Central Valley Regional Water Quality Control Board

TRANSMITTAL OF SITE INSPECTION REPORT; RECOLOGY YUBA-SUTTER LANDFILL, MARYSVILLE, YUBA COUNTY

INSPECTION REPORT

FACILITY NAME: Recology Yuba-Sutter Landfill

Attachment 2. Photograph and Sampling Locations

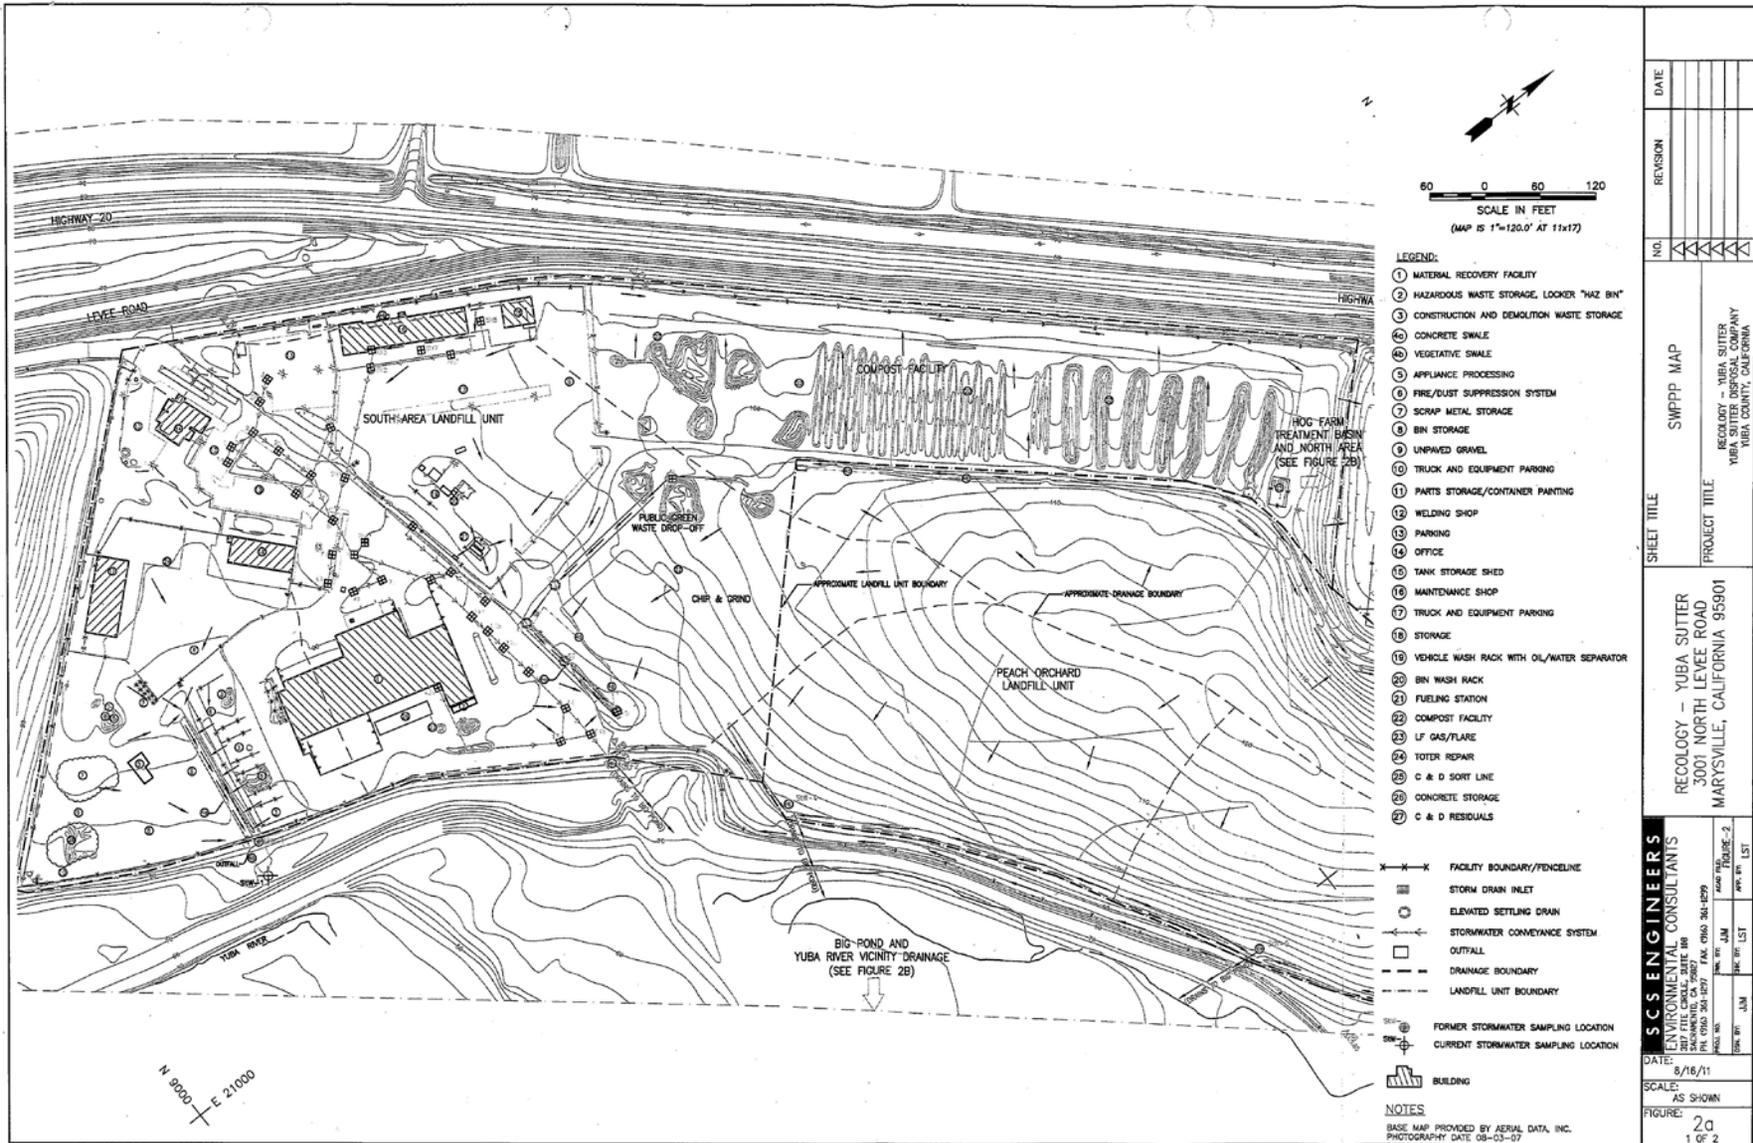
6. Landfill gas shall be actively removed to prevent migration of VOCs in landfill gas to groundwater per Title 27 §20917 et seq. Attachment 2 does not show landfill gas extraction wells (depicted by red dots) distributed over LF-1. Recology is currently implementing corrective action for excessive methane gas levels (exceeds 5%) in gas probe GP-14.

7. Postclosure land use at the site shall not interfere with the function of gas monitoring and control systems per Title 27 §20921(e). Attachment 2 shows numerous buildings and roadways that may interfere with the installation of a gas control system over LF-1.

Attachment 3. NPDES Industrial Storm Water Pollution Prevention Plan (SWPPP) Map

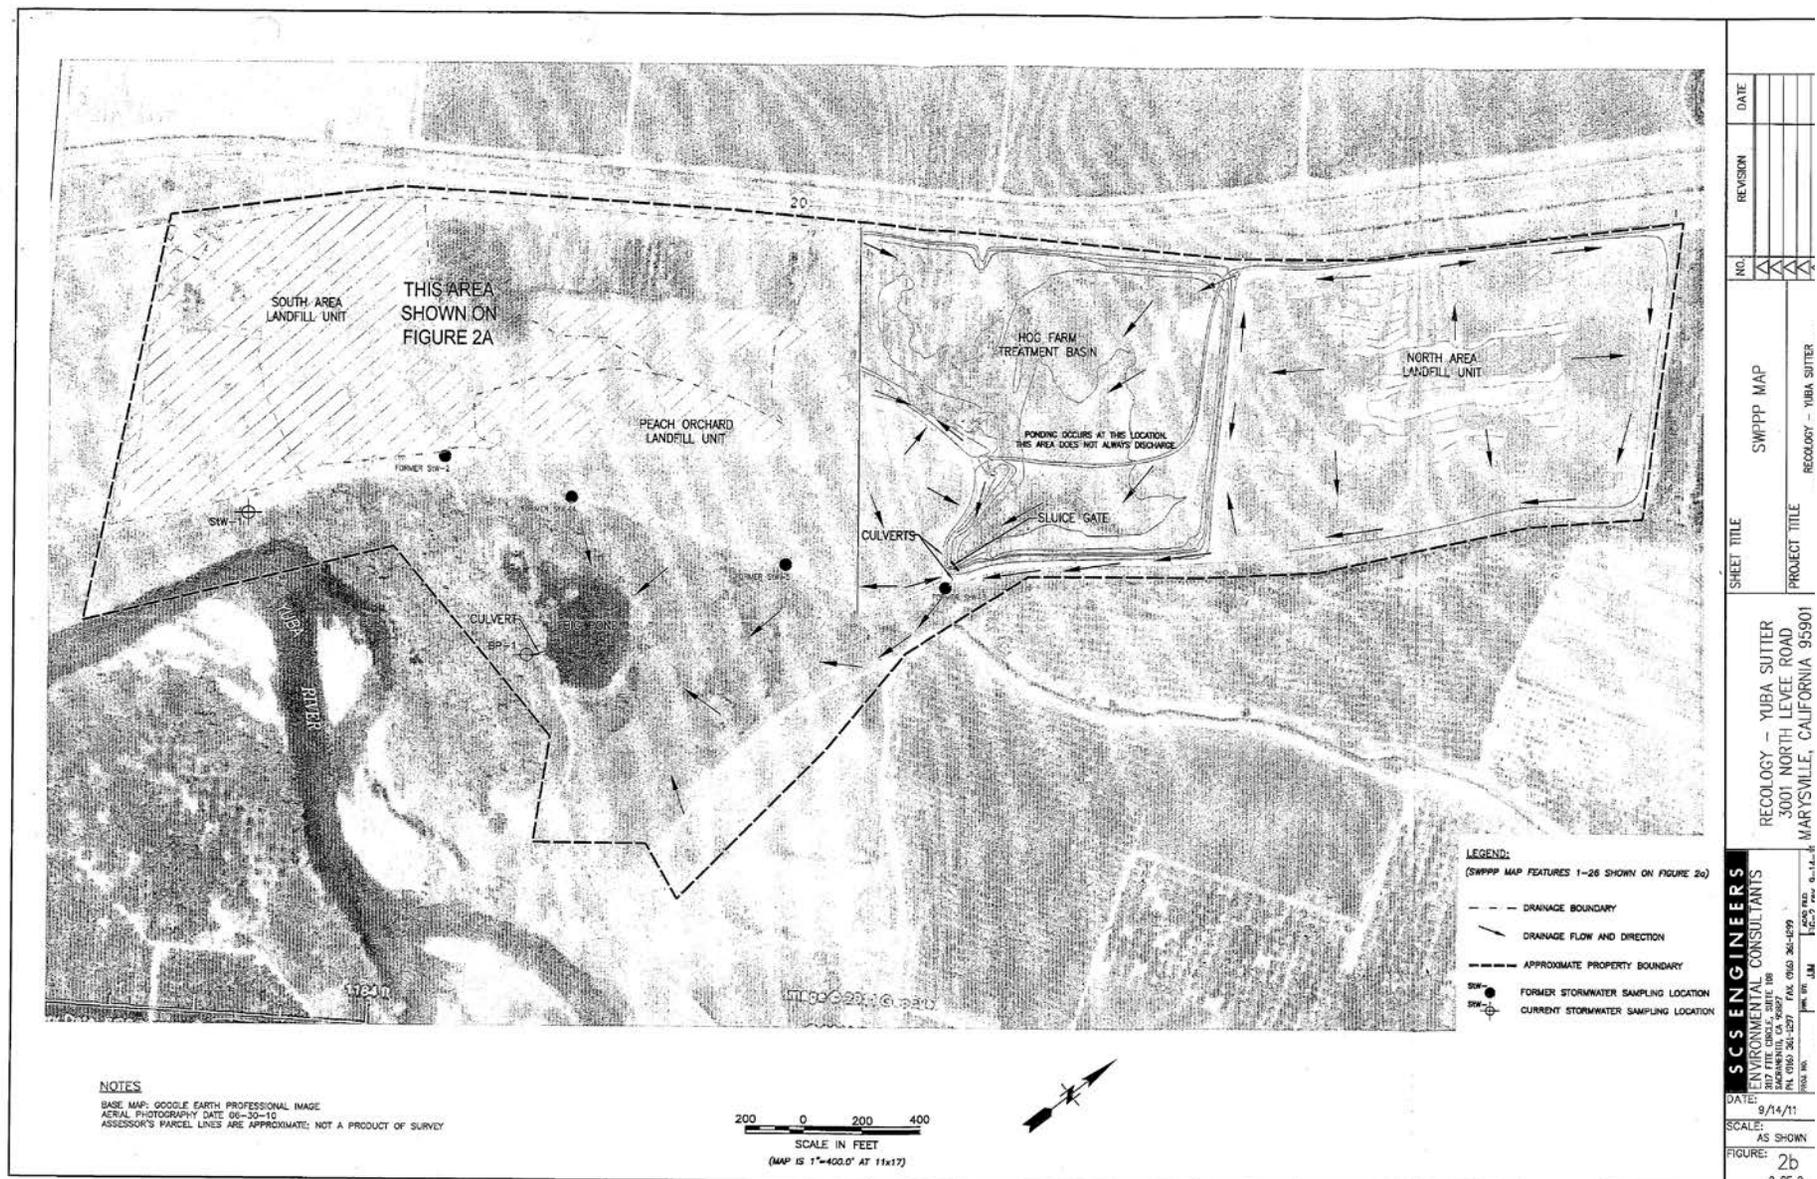
Photo# 5 shows the discharge of storm water that drains the chip and grind area identified on the SWPPP map in Attachment 3. The discharge could be characterized as a dark red/brown soup-like liquid. This discharge was sampled (See Photos# 19-21 description for details) at the entrance to the culvert shown in Photo# 5.

Photos# 11-14 show the active composting area. Photos 12-14 were taken from the road along the LF-2 WMU looking north-westerly down the rows of composting material. The photos show ponding. Leachate from the composting piles flows away from where the pictures were taken towards Levee Road. The leachate is then directed towards the Hog Farm Area as shown on the SWPPP map. This is where it is disposed of as shown in Figure 2b of the SWPPP map.

- g. The discharge of leachate from the composting area is to the “Hog Farm Treatment Basin” identified in Attachment 3. Page 2 of Attachment 3 indicates that ponding occurs within the Hog Farm area which discharges periodically to the Big Pond. Recology indicates that leachate from the composting area is currently being treated within the Hog Farm area. In order to claim treatment of the composting leachate Recology must show that leachate nutrients are being applied at agronomic rates to Hog Farm vegetation that is protective of groundwater from excessive application of nitrogen (from ammonia+nitrate+nitrite), TDS, or TOC.
